Project Name: Studio 404 Frozen Daiquiri Bar and Café (2016-212)

Request: Class III Site Plan Modification

Board: Site Plan Review and Appearance Board

---STAFF REPORT---

Calculation Summary							
Scene: Scene_1							
Label	CalcType	Units	Avg	Max	Min	Avg/Min	Max/Min
ALL CALC POINTS	Illuminance	Fc	2.95	9.5	0.1		
PARKING AREA SUMMARY	Illuminance	Fc	3.2	9.5	0.5	1.2	5.1

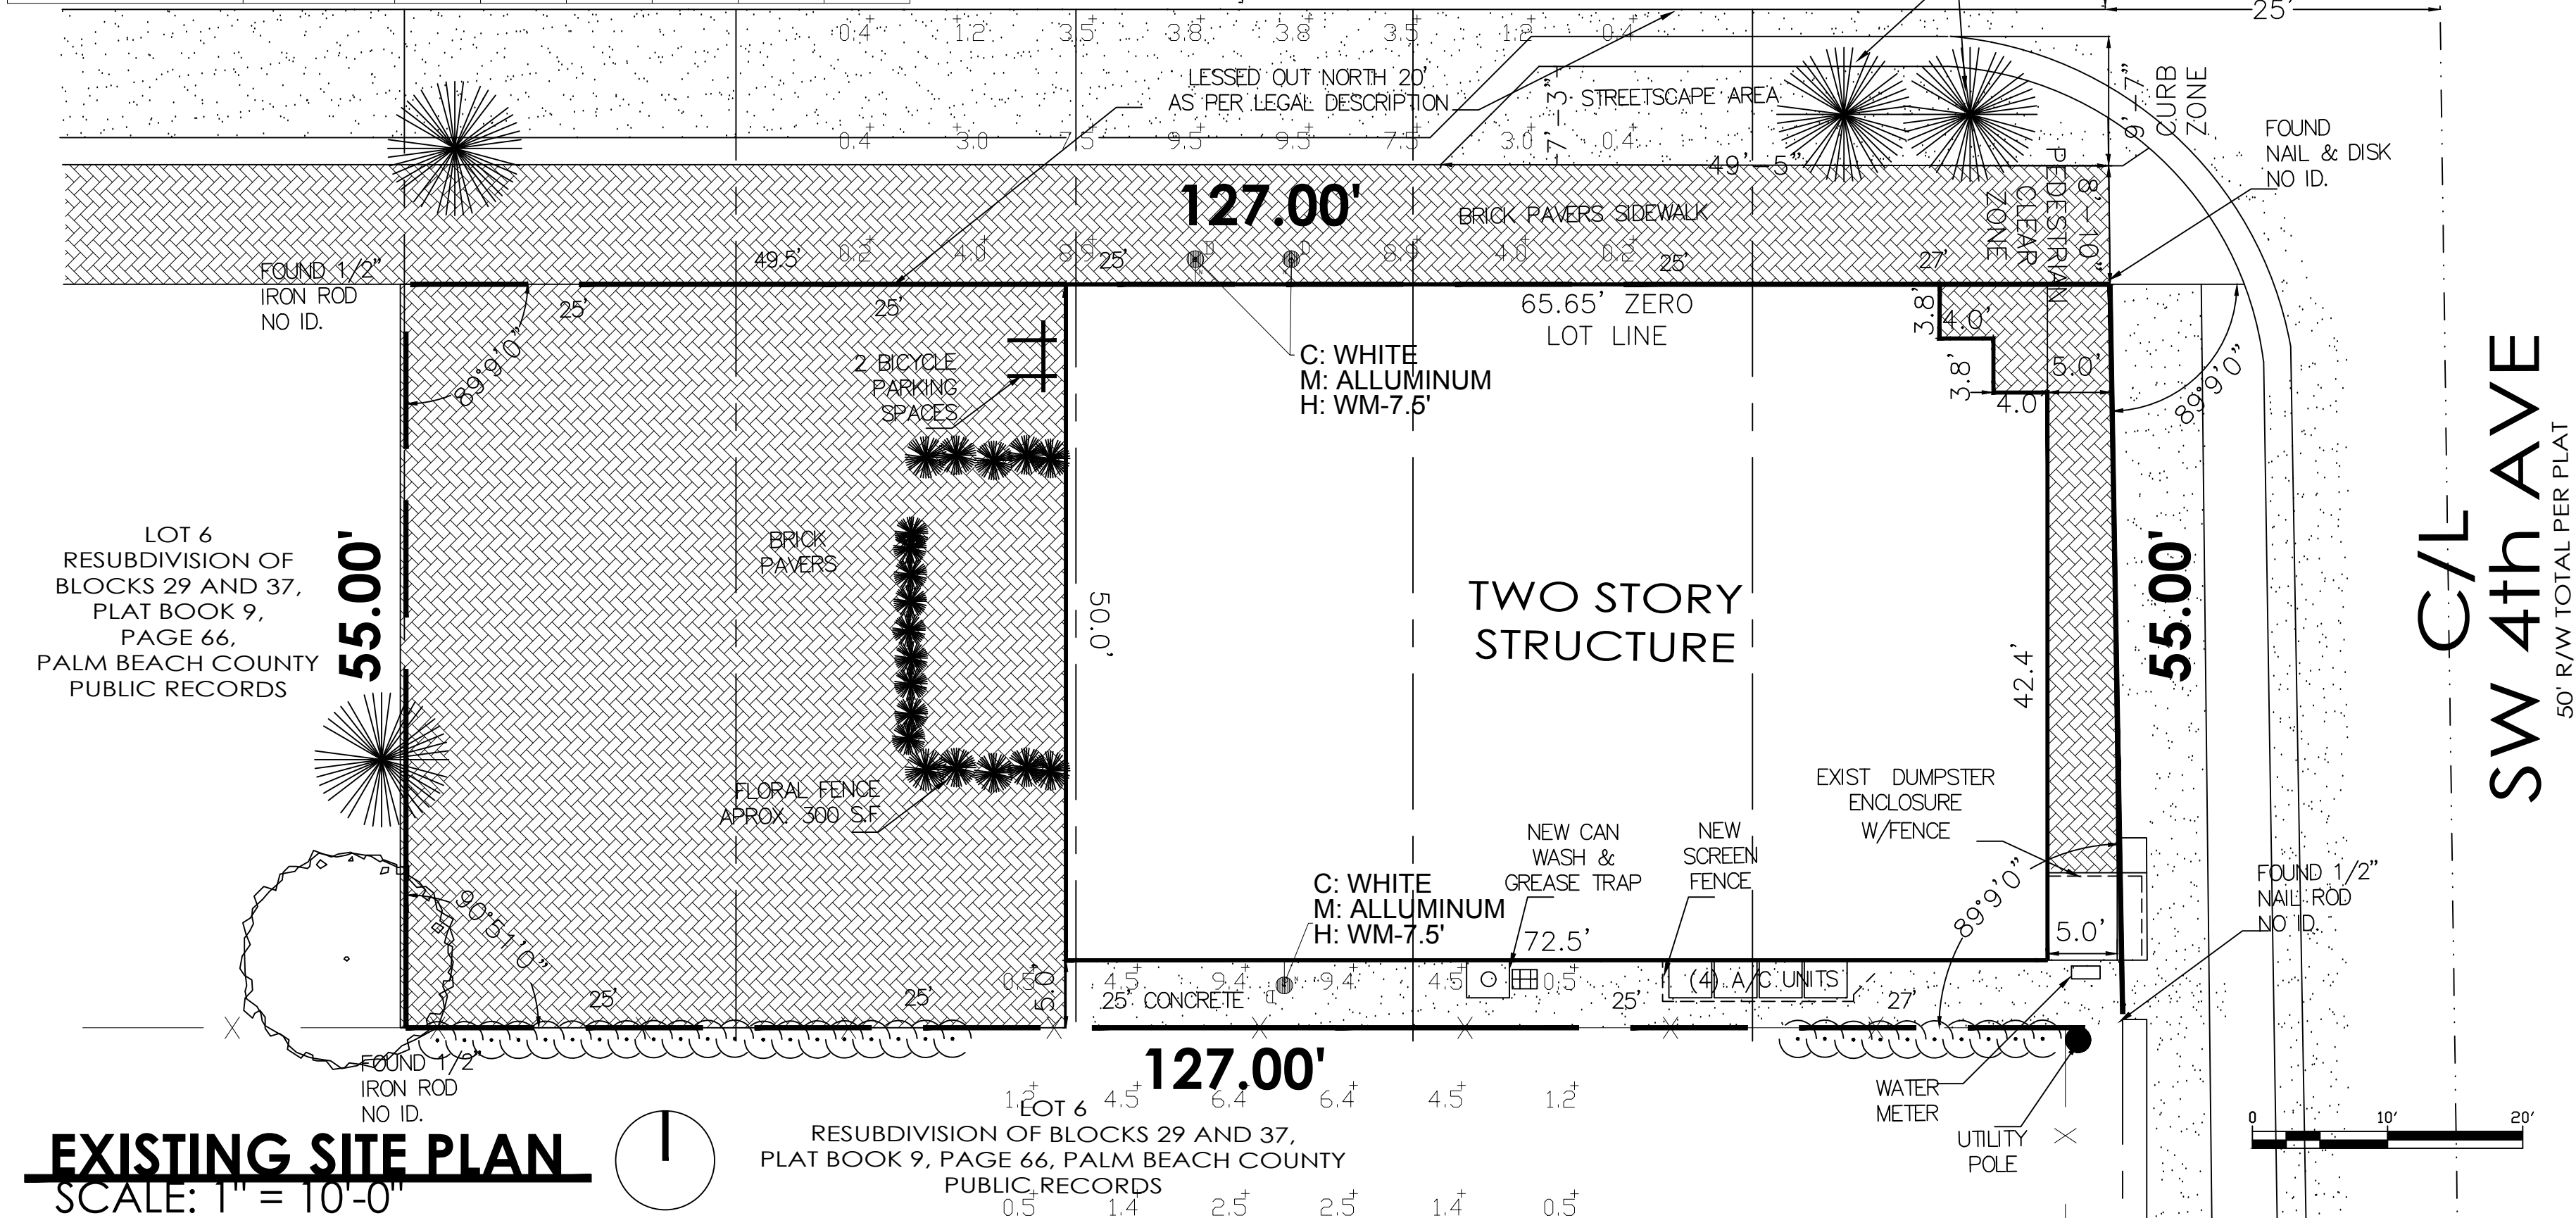
3. The photometric plan be revised to apply the proposed illumination levels to the outside entrances per LDR Section 4.8.6. This condition shall be addressed prior to certification of plans.

4. The photometric plan be revised to apply the proposed illumination levels to the outside entrances per LDR Section 4.8.6. This condition shall be addressed prior to certification of plans.

NORTH ELEVATION

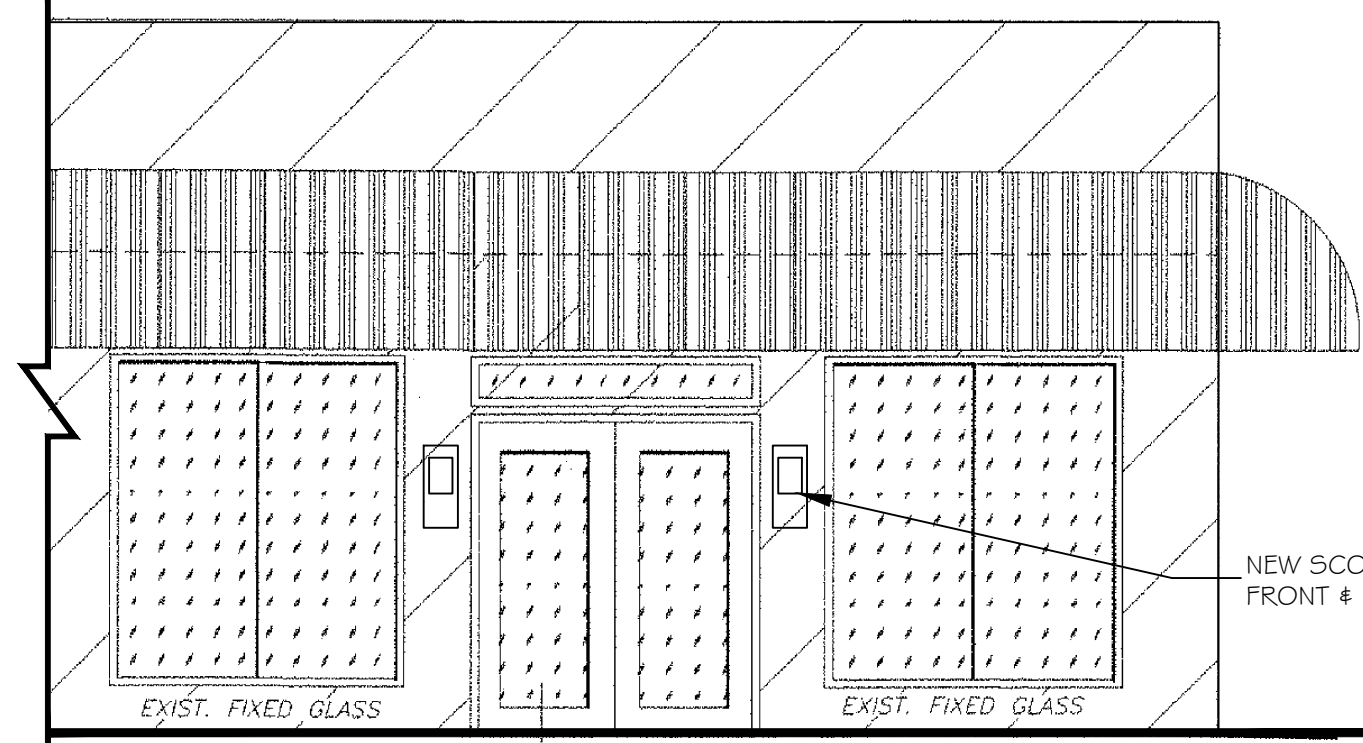
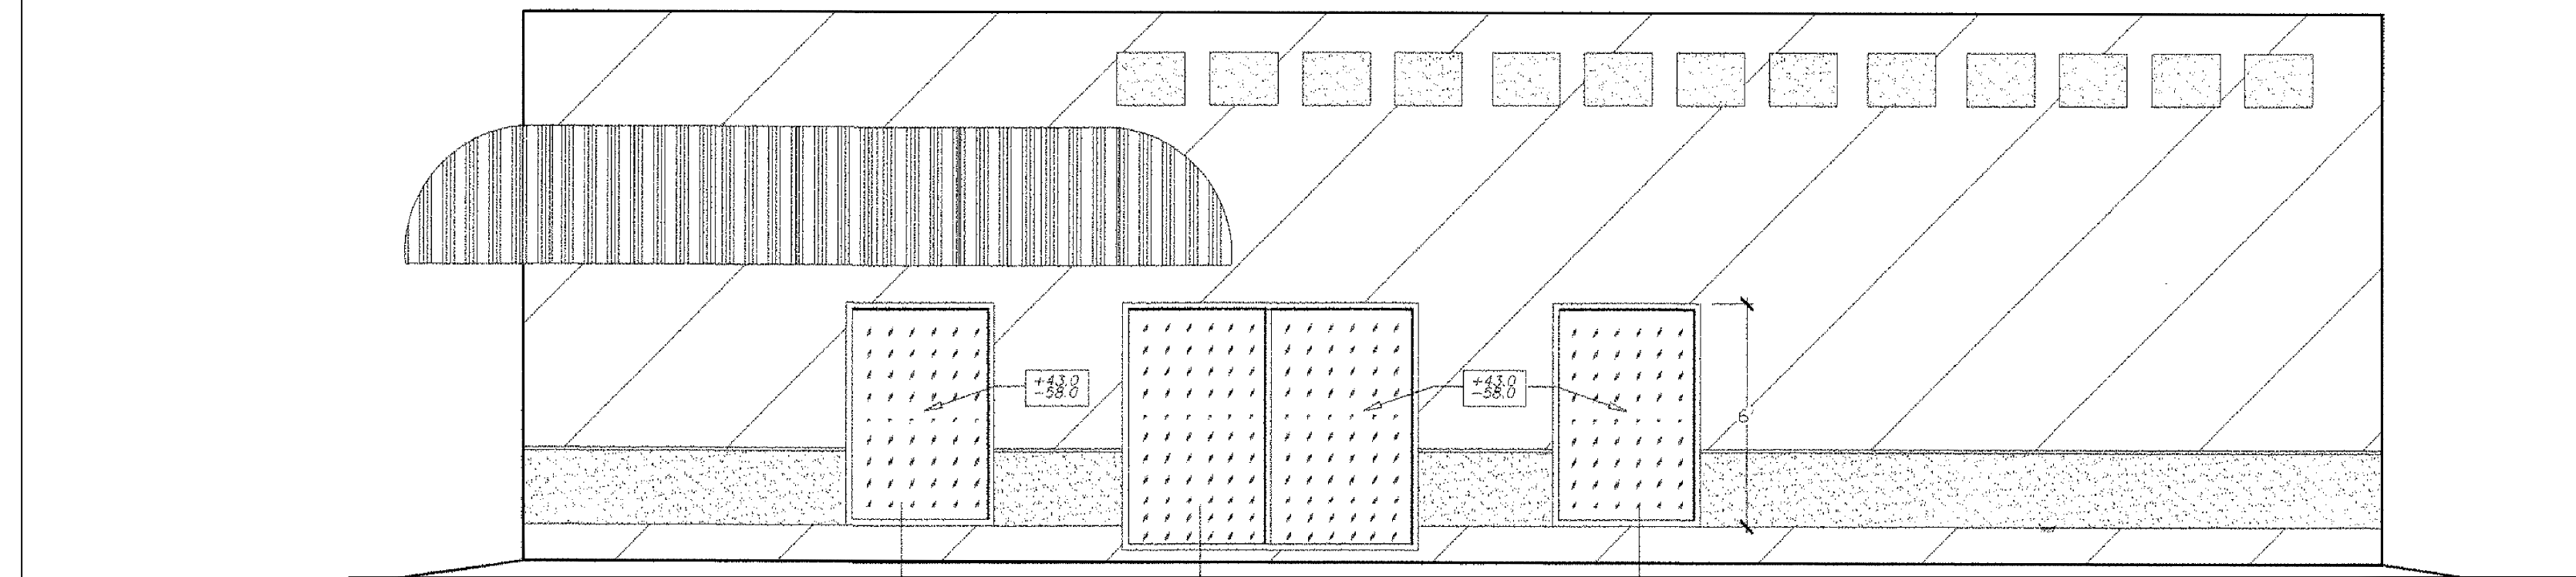
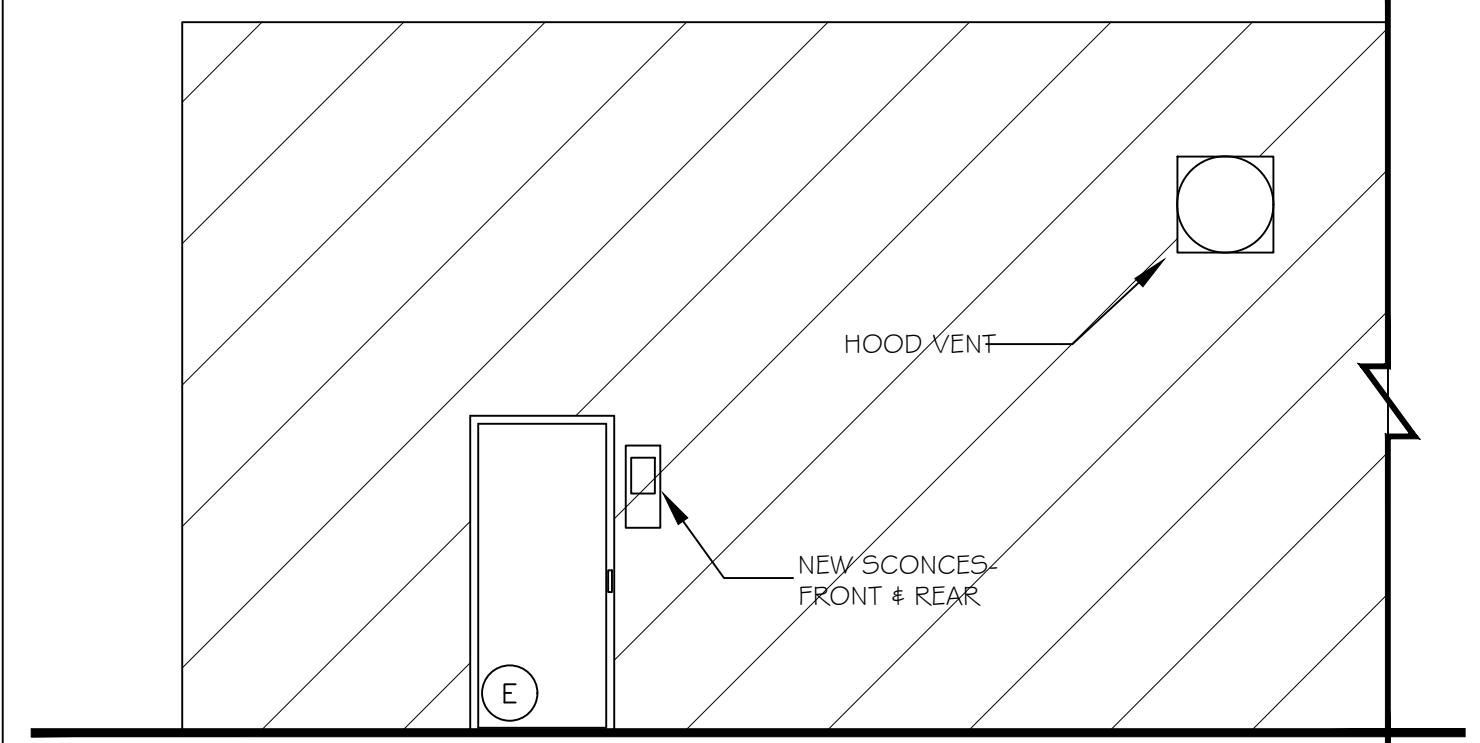
The proposed improvements to the existing north, south and west elevations include introduction of new window and door openings, new light sconces and decorative shutters, and architectural modifications to accommodate the proposed use. The existing storefront entryway door will be replaced with a double door without modifying the existing opening and the existing windows will remain unaltered. The existing awnings will be removed and decorative turquoise metal Bahama shutters will be introduced above the openings. The proposed shutters will extend into the public right-of-way. Pursuant to LDR Section 4.3.4 (H)(4)(o), canopies, marquees and covered walkways may extend into the public right-of-way when approved by the Chief Building Official through approval of an applicable agreement with the City. Therefore, the execution and recordation of a Canopy Hold Harmless Agreement prior to issuance of a building permit is listed as a condition of approval.

The proposed façade color is a white with a turquoise trim. New sconces will be introduced. The proposed sconces are not consistent with the architecture and the proposed color palate of the building. The Board may want to consider different sconces and/or color. In addition, new window and door openings are proposed on the west elevation which will serve to provide visibility and access to the proposed outside dining area. The proposed 300 sq.ft. outside dining area will be bounded by planters. No information regarding the planters or the landscape material to be installed within the planters was provided. It is listed as a condition of approval that a manufacturer' cut sheet for the proposed planters be provided prior to certification of the plans, and that the proposed landscape material to be installed within the planters be reviewed and approved per the direction of the Senior Landscape Planner.

1. Plans be revised prior to site plan certification to provide the dimensions of the decorative shutter encroachment into the right-of-way;
2. A Canopy Hold Harmless Agreement for the Bahama shutters encroaching into the right-of-way be executed and recorded prior to issuance of a building permit;
3. The proposed hood vent be painted the same color as the rear wall. This condition shall be addressed prior to certification of plans;
4. A manufacturer's cut sheet be provided for the proposed hood vent prior to certification of plans.
